Product Change Notice (PCN)

Subject: Assembly factory change for Shunt Regulator power supply IC

Publication Date: 2/13/2023

5p MM: Changed outline drawing. Some dimensions have changed (some notation methods have changed)

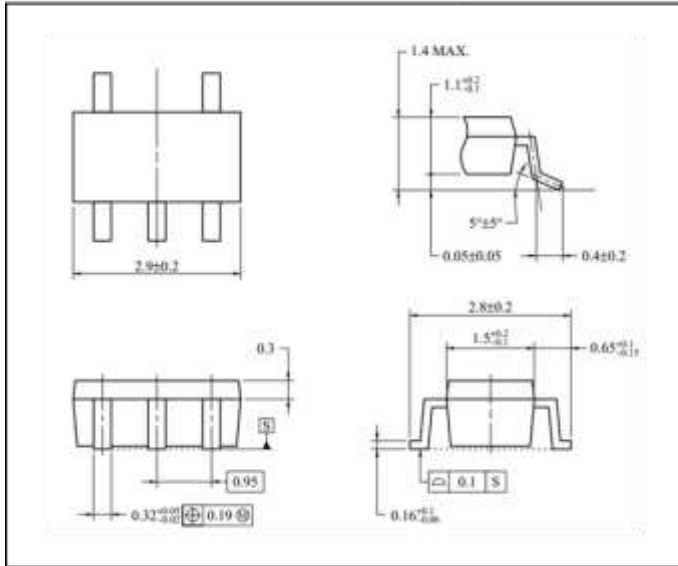
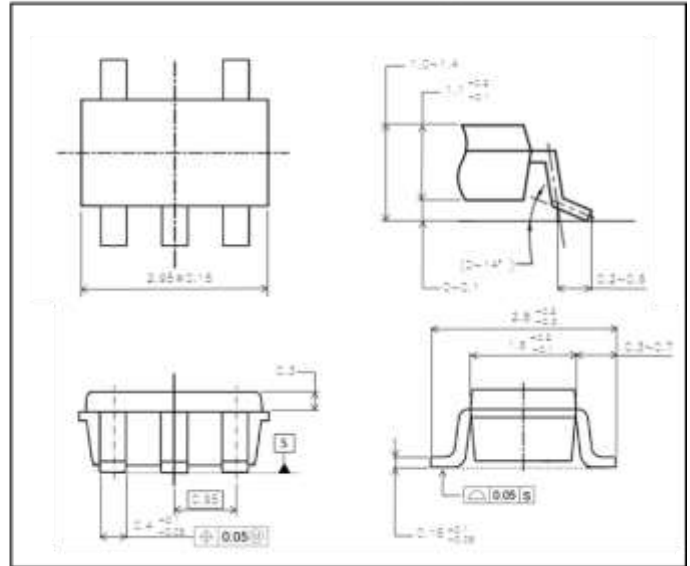
5p MM dimension changes are as follows.

Item	Before the change	After the change
Body width	2.9mm	2.95mm
Body vertical width [terminal direction]	1.5mm	1.6mm
Terminal width	0.32mm	0.4mm

< 3p PoMM >

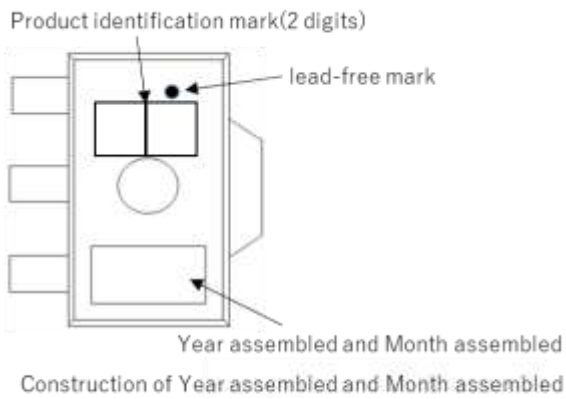
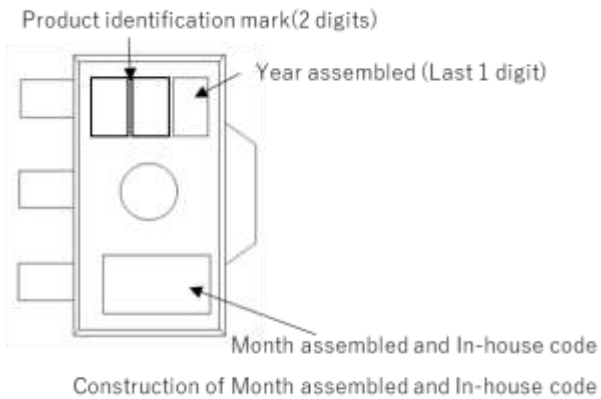
Construction of Year assembled and Month assembled

Construction of Month assembled and In-house code

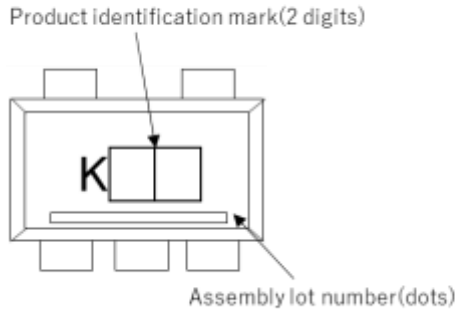
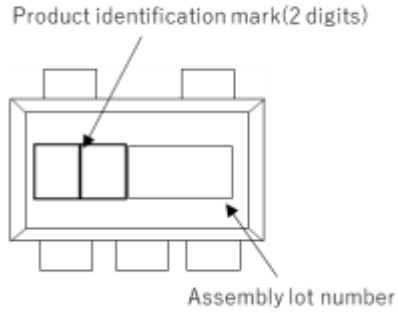
Construction of lot number

Construction of lot number
